Marine liferafts — Inflation system :
Introduction of updated Leaffield GIST operating head

This Service Bulletin has been technically approved by Survitec Design Authority.

FIGURE 1
Old design
Leaffield GIST operating head

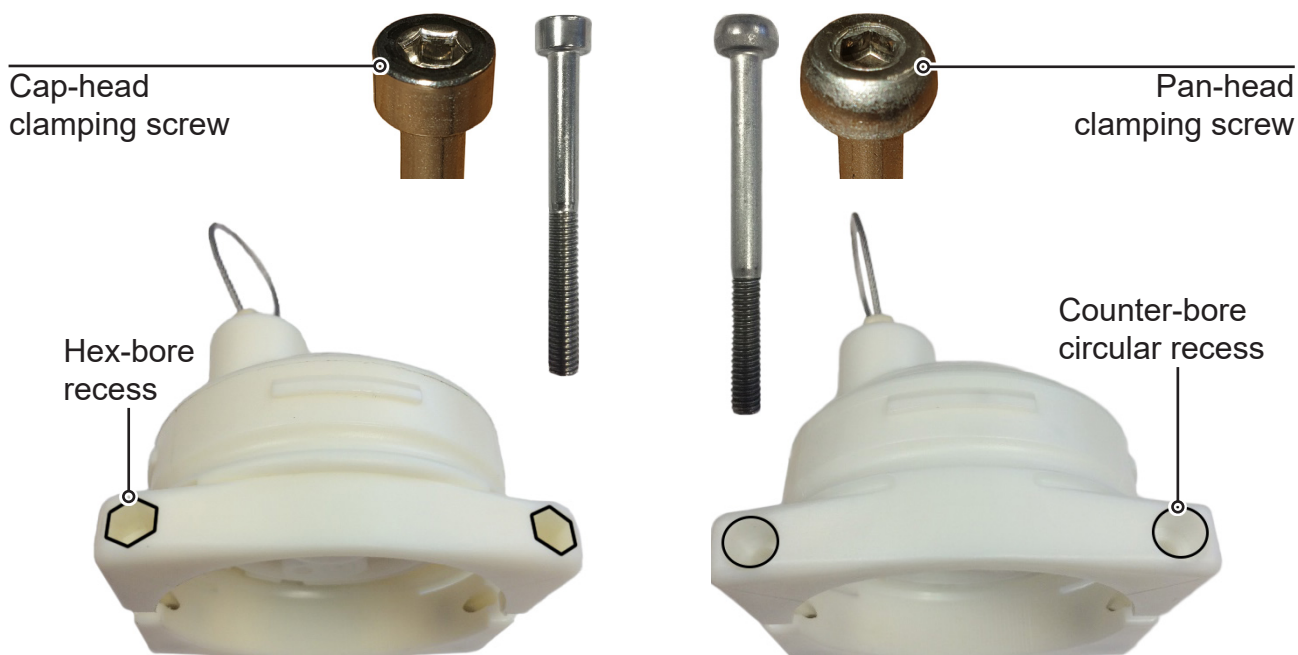
The design of the Leaffield GIST operating head and clamping screws has been changed. The new design has counter-bore circular recesses which uses pan-head clamping screws. The old design has hex-bore recesses and uses cap-head clamping screws.

- cap-head clamping screws on the old design Leaffield GIST operating head. Refer to **Figure 1**.
- pan-head clamping screws on the new design Leaffield GIST operating head. Refer to **Figure 2**.

NOTE: The pan-head clamping screw is longer in length and has a rounded head.

CAUTION: THE CLAMPING SCREWS ARE NOT INTERCHANGEABLE.
THE INCORRECT CLAMPING SCREWS WILL NOT ATTACH TO
THE OPERATING HEAD.
